FORMER NESTLE CANTEEN

Facade retention study - REV A

April 2022

Single-glazed windows to be replaced

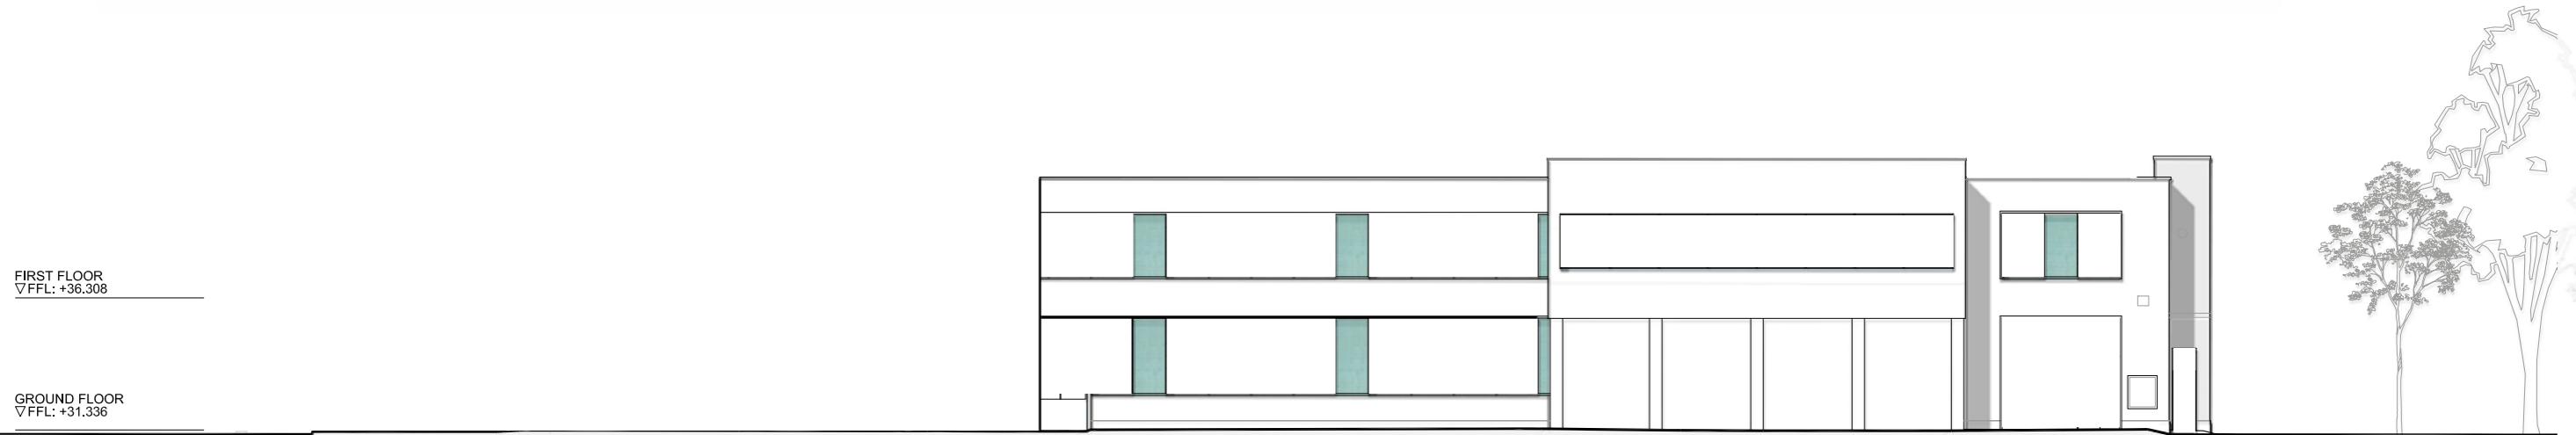
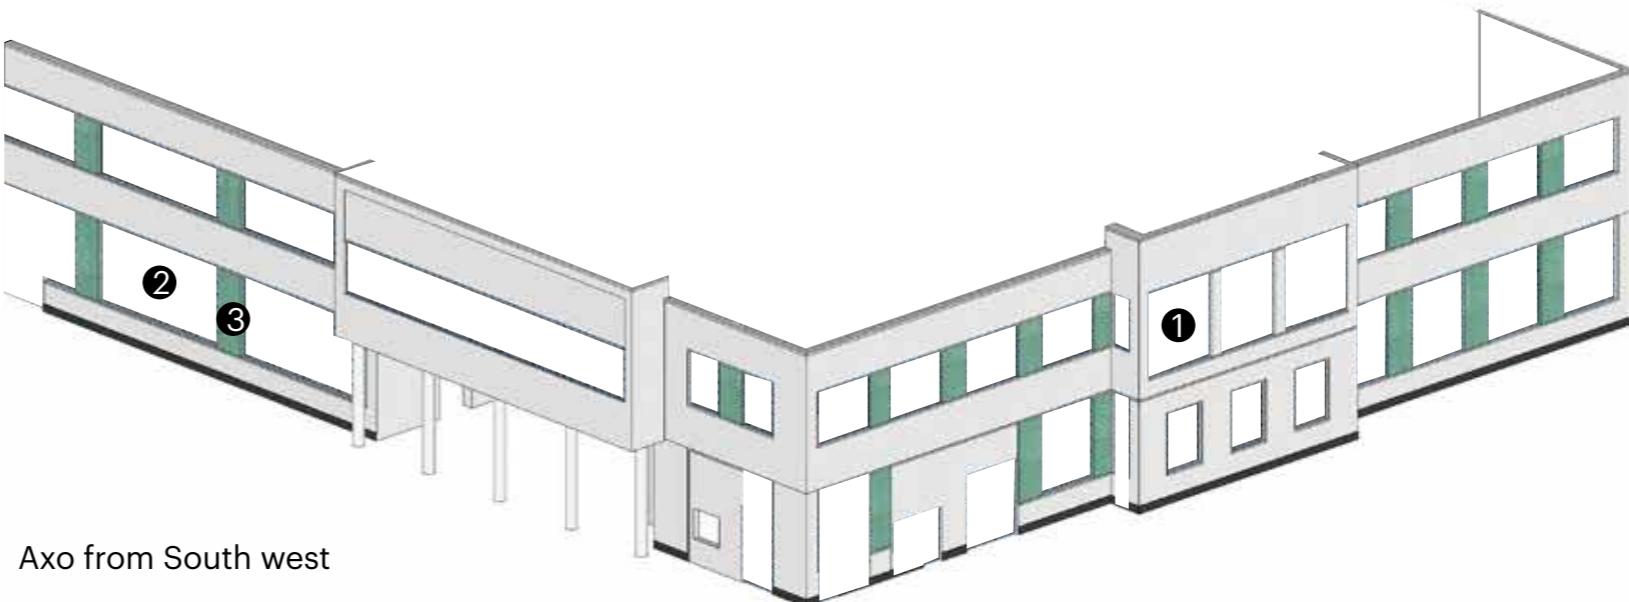
1. The existing windows are single-glazed steel framed, and need to be replaced with thermally broken double glazed in order to meet the NHS requirements of a sustainable BREEAM excellent medical centre. The proposal is for the same crittal style aluminium window frames used on blocks F1 and G, which appear in keeping with the original aesthetic.

2. To facilitate the medical centre design and room sizes, the existing window spans on the West facing elevation will need to be subdivided by half; the junction of wall to window detail draws from the original design, using a vertical green tile panel junction.

3. The existing green tiles are damaged or missing in areas; to ensure consistency with the new panels, all the tiles are to be removed and replaced with new green tiles, using the same product and supplier as the tiles used on blocks G and F1; these three buildings will complete the composition around Wallis Gardens

OPTION 1 - Extent of facade remaining if steels do not require treatment

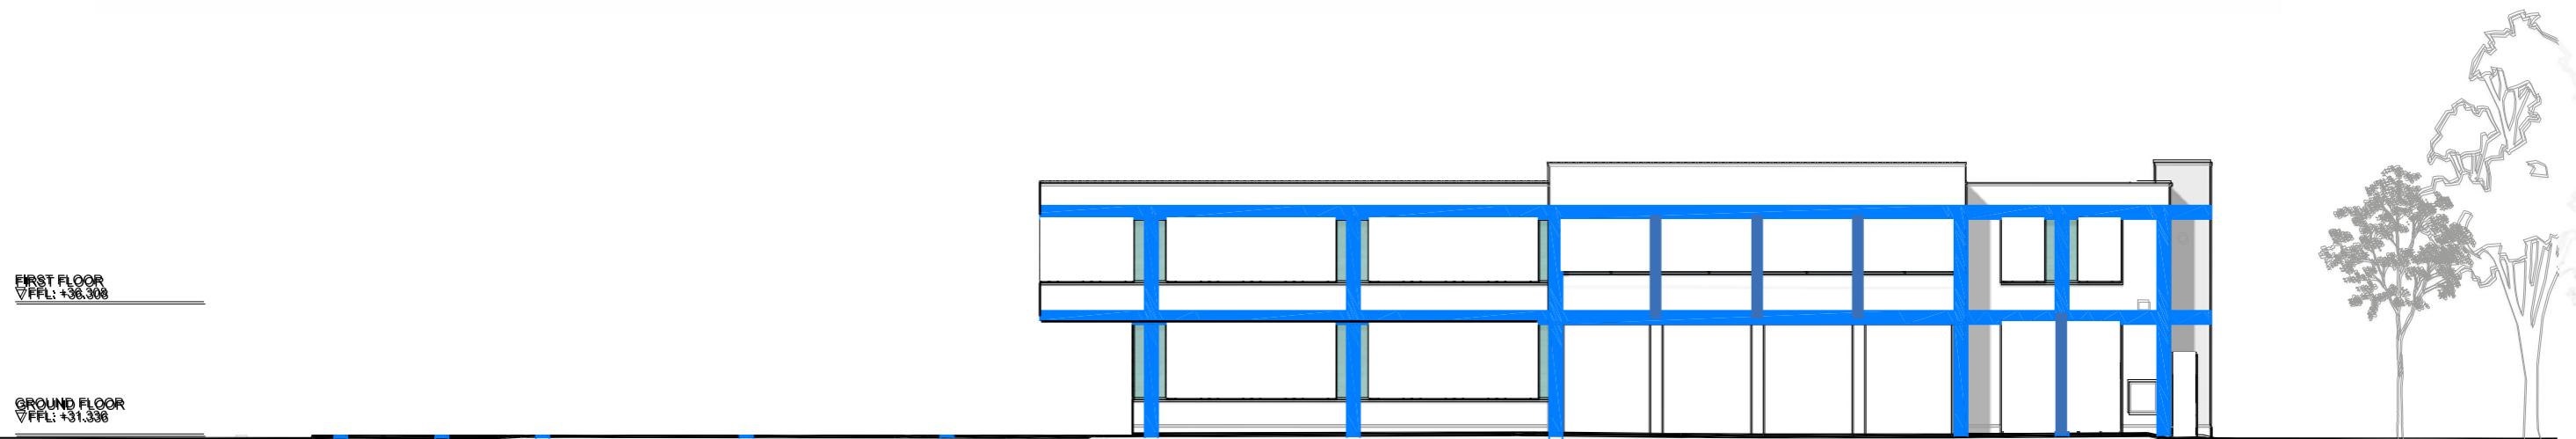
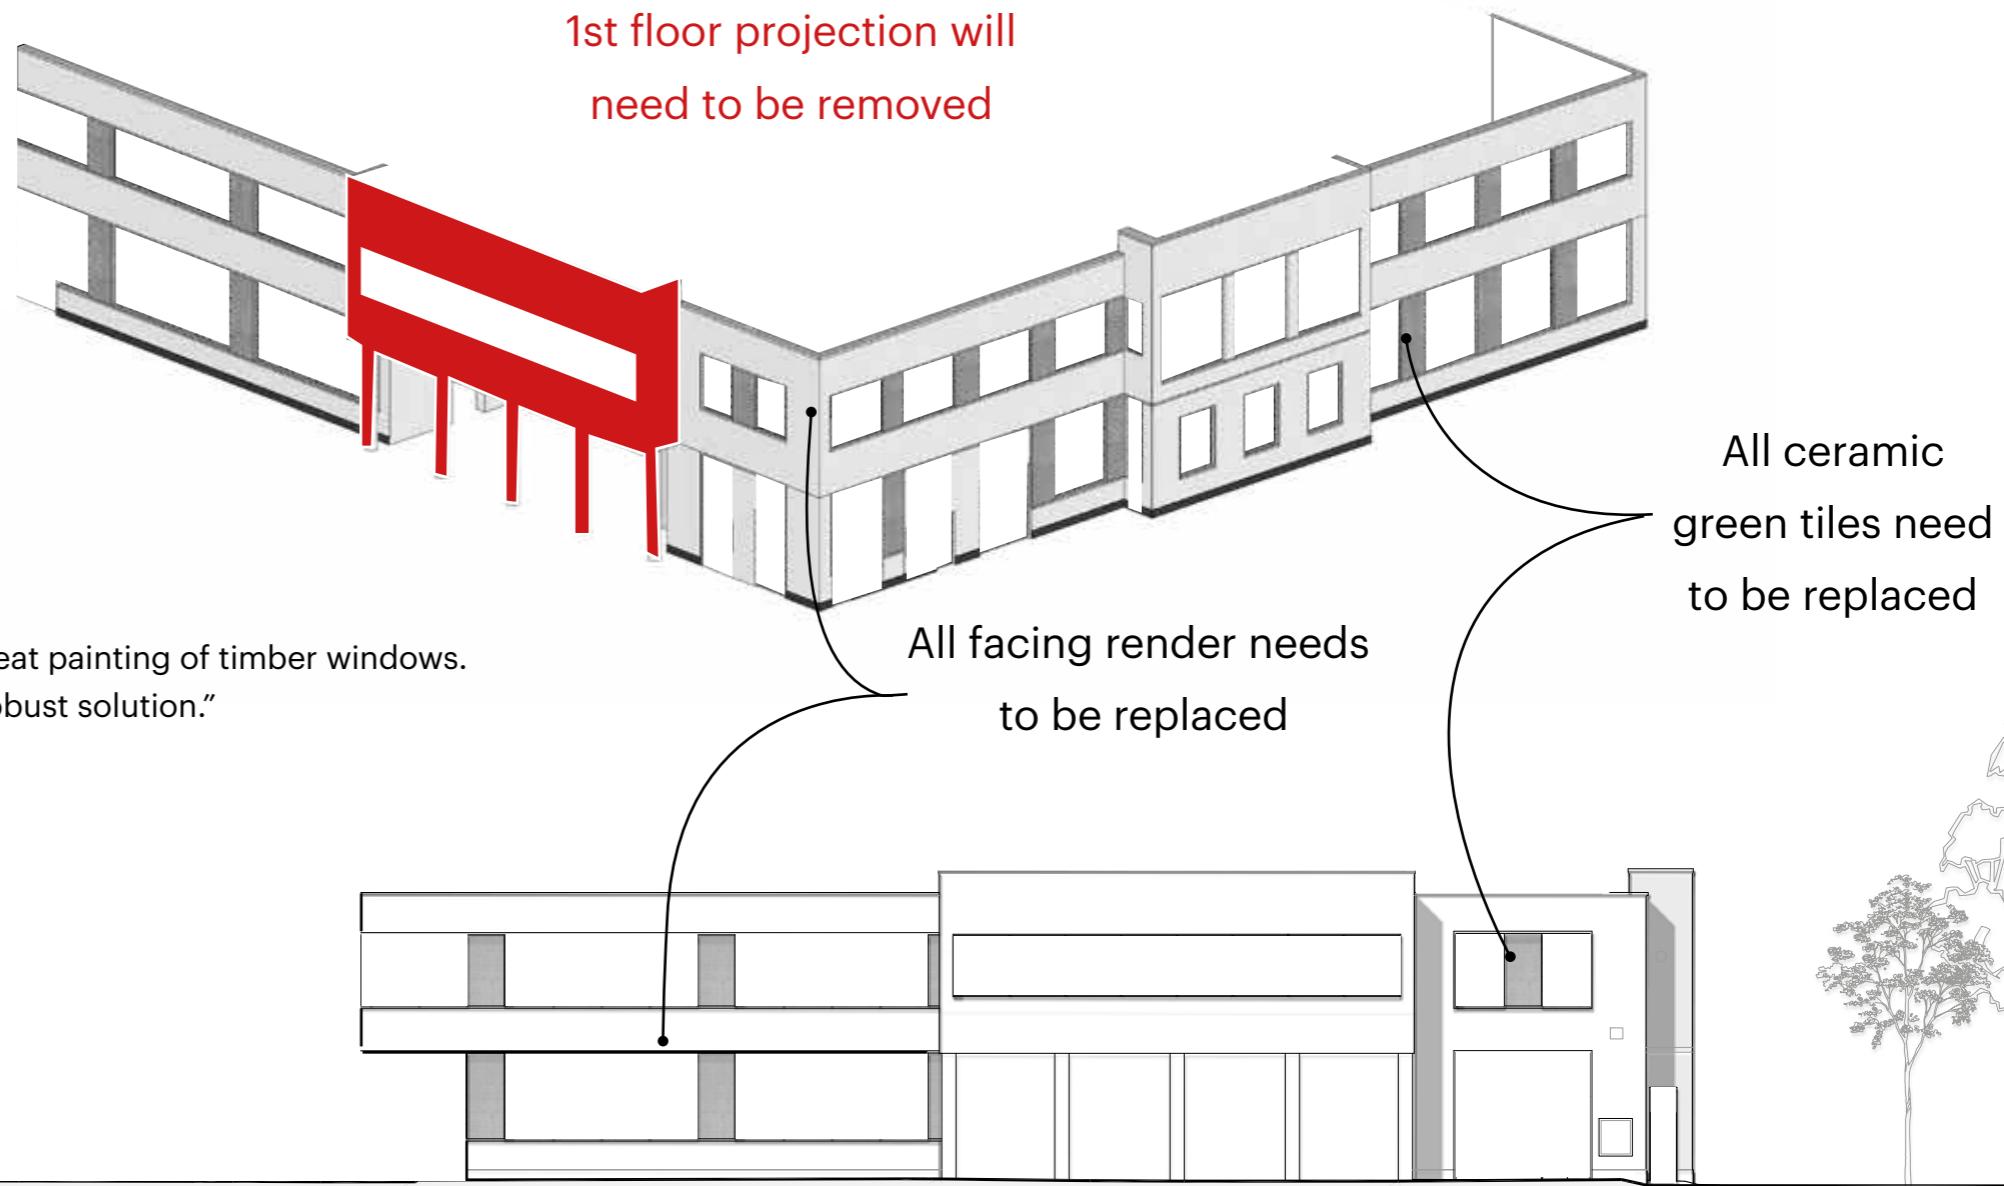
The steel beams and columns are encased in brickwork. This detail was typical during midcentury construction - particularly as a way of creating a modernist concrete aesthetic - but is now understood as a poor detail due that allows water ingress to damage the steelwork, often creating structural damage referred to as 'Regents street disease.' By today's standards, any retained steelwork would be categorised as primary structural elements, and would therefore need to provide a 60 year minimum lifespan.

This option relies upon a sealant applied to the outer layers of render to prevent future moisture ingress. However, initial comments from NHBC is that relying on, "a paint-on solution requires periodical application and may affect how the building breaths (interstitial and surface condensation). Any periodical maintenance required would need to be done by operatives who are suitably trained in the product and this is likely to be part of a condition of warranty - for example similarly to the repeat painting of timber windows. Given the end user and possible cost, this is a risk and is not a robust solution."

OPTION 2 - Extent of facade removed if steels require treatment

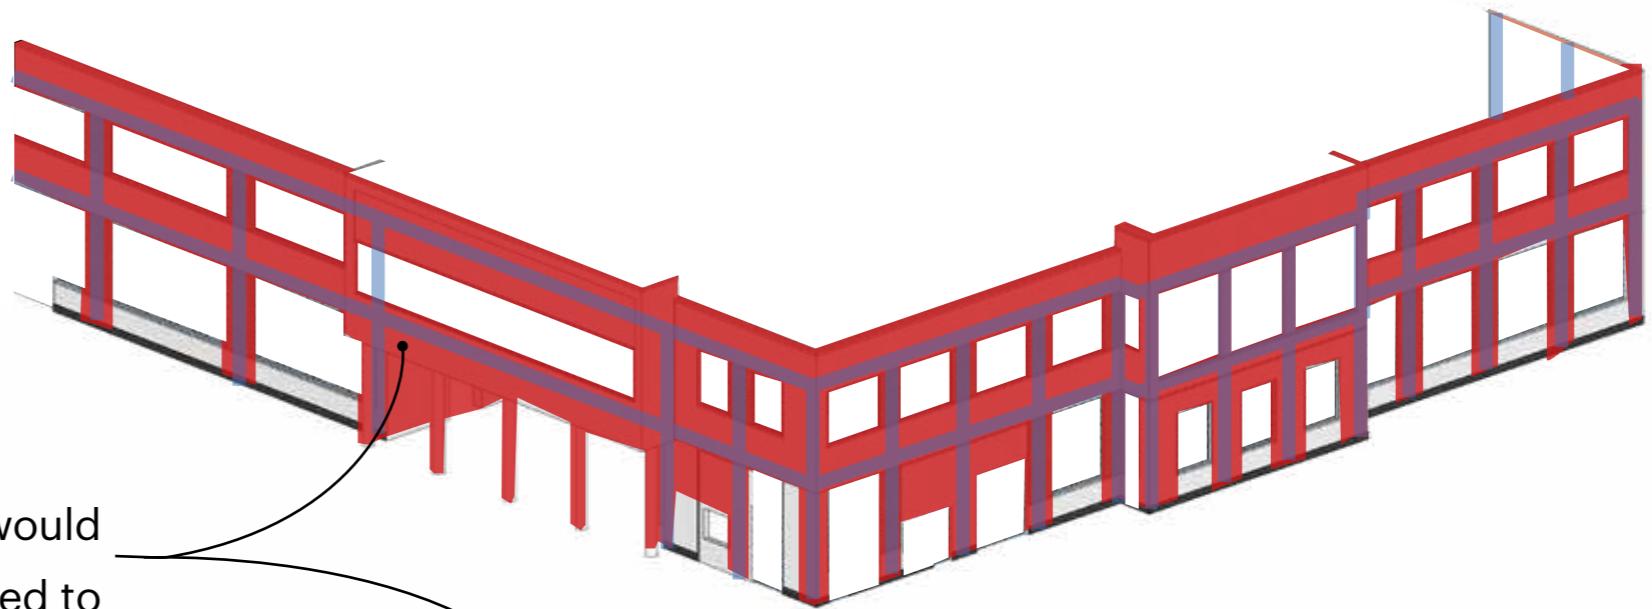
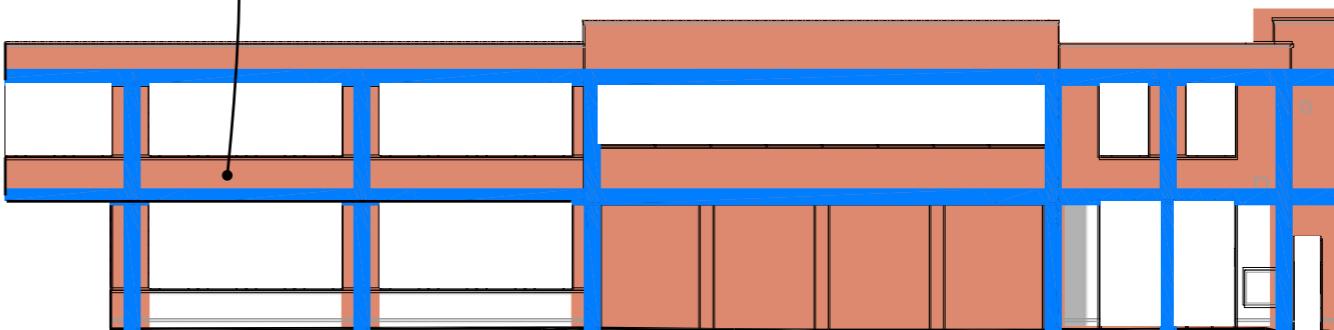
In order to achieve a robust remedial detail to retain the steels and provide a 60 year lifespan that would satisfy the NHBC warranty, it is likely that the steels would need to be fully exposed in order to provide repairs and protection from future moisture. This would require the removal of all the brickwork shown in red opposite, to be rebuilt.

By this point, for all intents and purposes, only the steel-work remains from the original fabric.

majority of brickwork would need to be removed to enable access to steels
